The Commission has issued the enclosed Amendment No. 74 to Facility Operating License No. DPR-59 for the James A. FitzPatrick Nuclear Power Plant. The amendment consists of changes to the Technical Specifications in response to your request dated May 25, 1983. The changes were necessitated as a result of new fuel loaded during the current refueling outage (Reload 5) to support power operation in Cycle 6.

JAMES A. FITZPATRICK NUCLEAR POWER PLANT

Amendment No. 74
License No. DPR-59

SAFETY EVALUATION BY THE OFFICE OF NUCLEAR REACTOR REGULATION
SUPPORTING AMENDMENT NO. 74 TO FACILITY OPERATING LICENSE NO. DPR-59
POWER AUTHORITY OF THE STATE OF NEW YORK
JAMES A. FITZPATRICK NUCLEAR POWER PLANT
DOCKET NO. 50-333

Figure 3.1-2

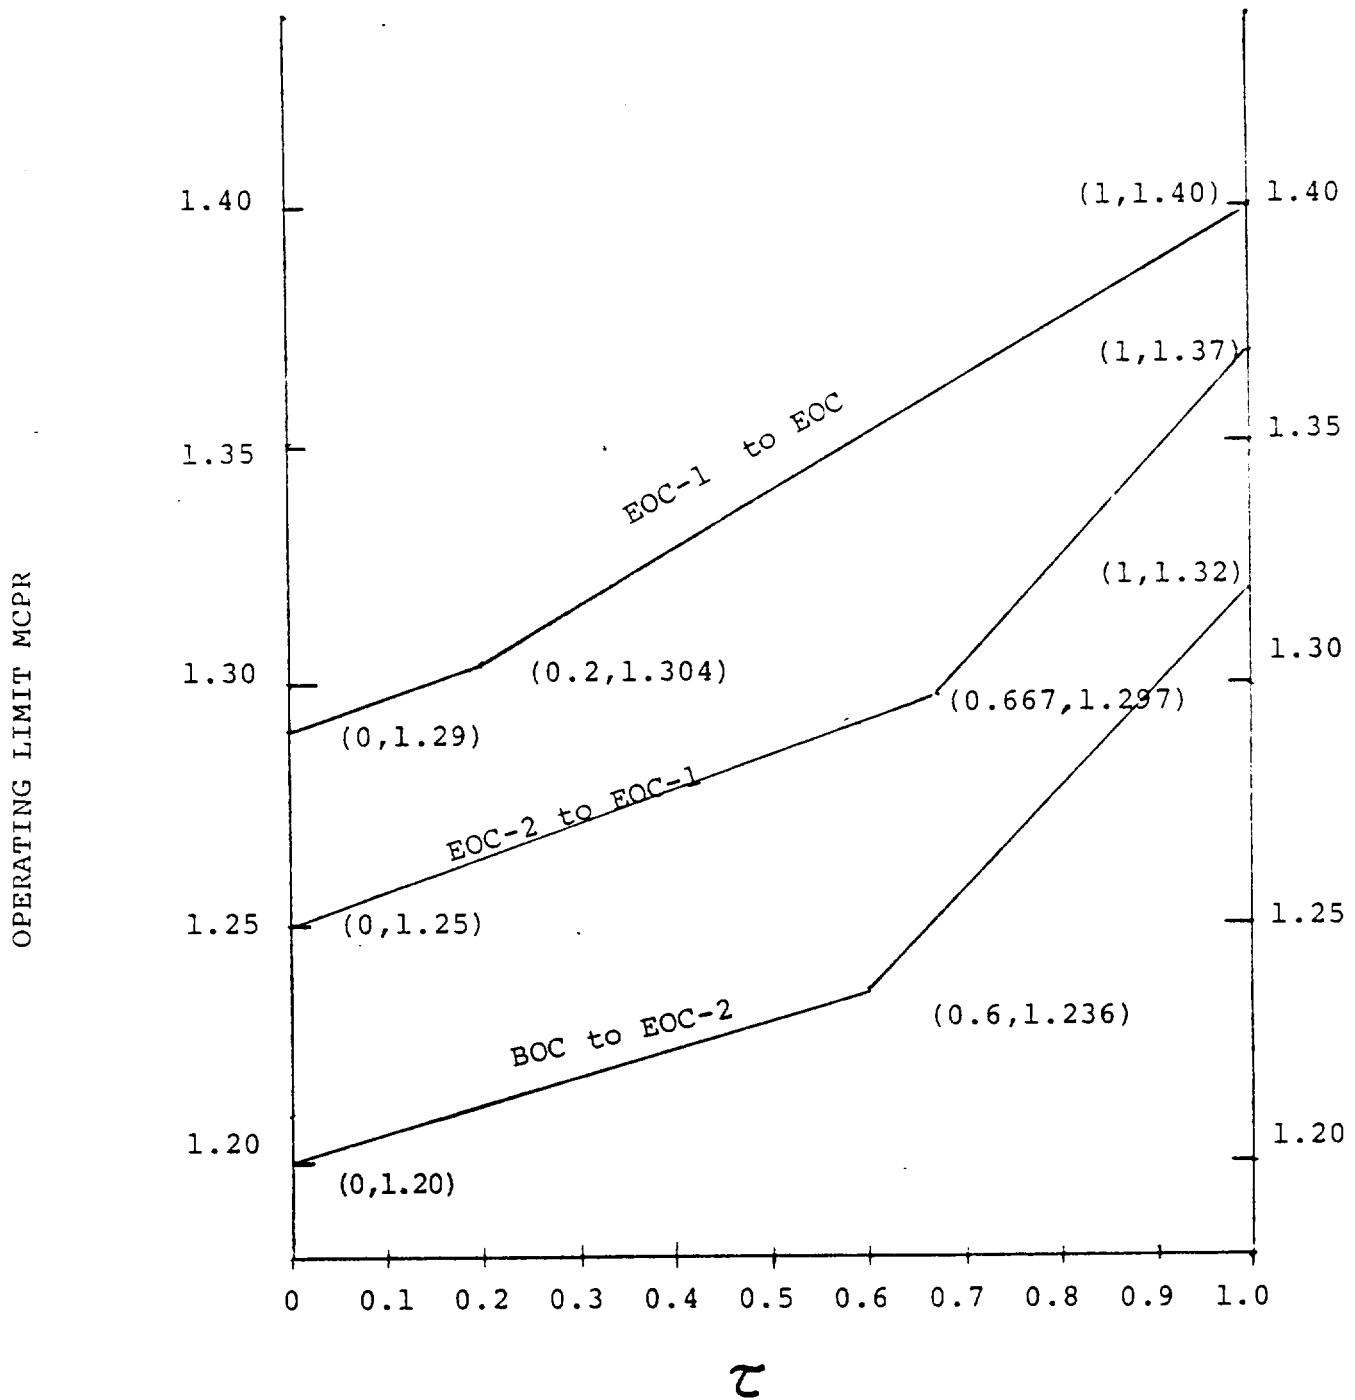
The two additional equations for the Rod Block Monitor setpoints are added in Specification 3.1.B and in the Notes for Table 3.2-3. These are acceptable. Figure 3.1-2 has been altered to reflect the MCPR operating limit as a function of T for the new cycle and MAPLHGR limits for the new fuel (Type P8DRB299) are added in Figure 3.5-10. These changes are acceptable.

Operating Limit MCPR
Versus τ (defined in Section 3.1.B.2)
FOR ALL FUEL TYPES

Figure 3.5-10

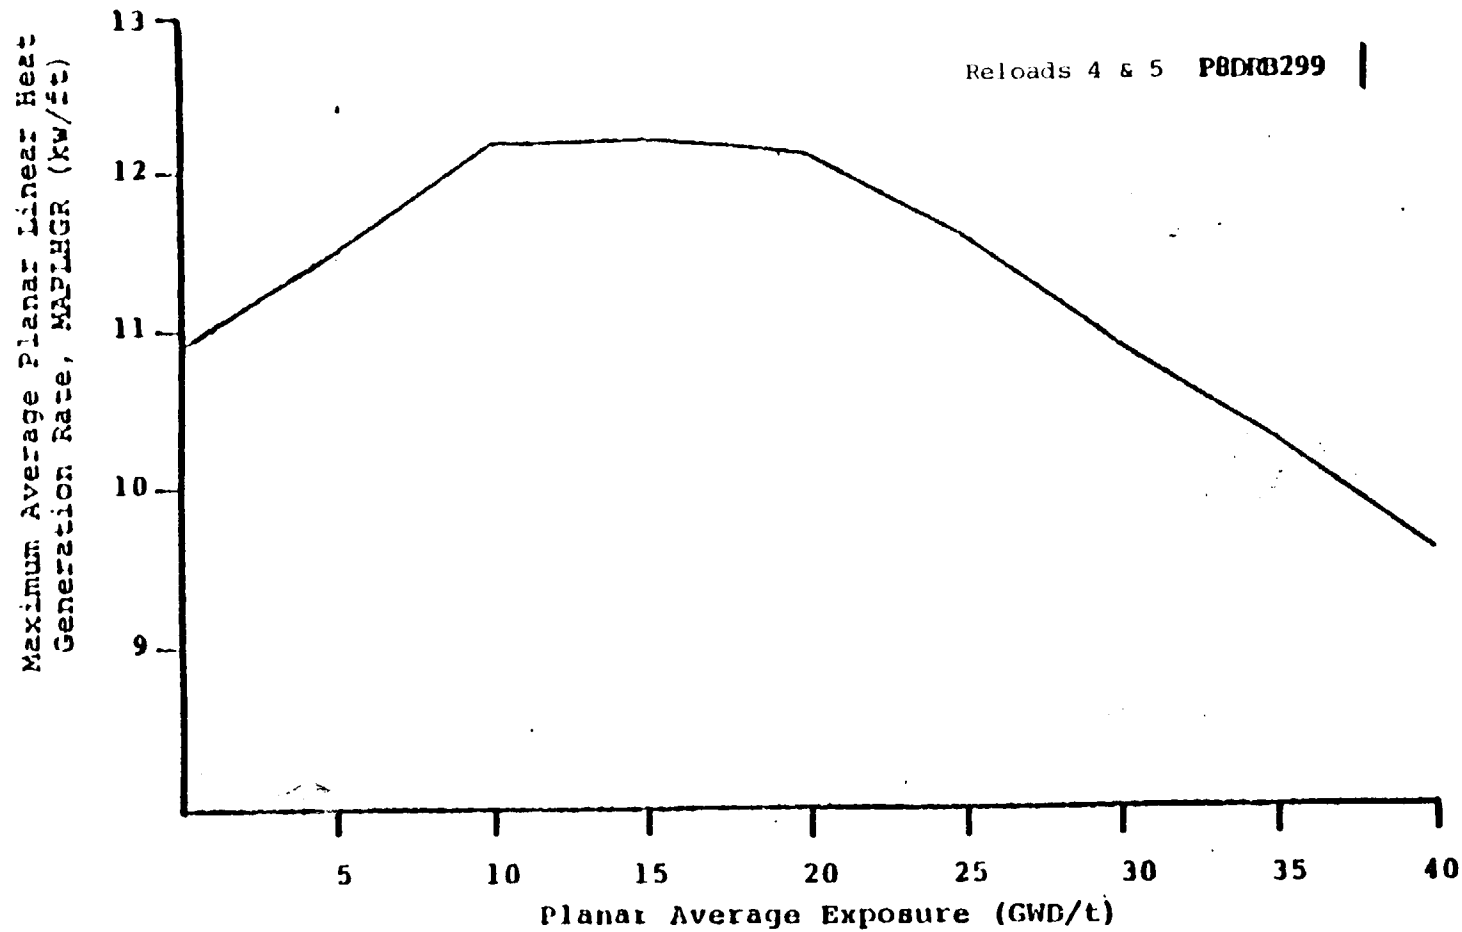
The maximum average planar linear heat generation rate (MAPLHGR) for the fresh fuel labeled Type P8DRB299 is identical to the previously approved MAPLHGR limit for the existing Cycle 5 fuel of the same type. We thus find the MAPLHGR limit acceptable for Cycle 6.
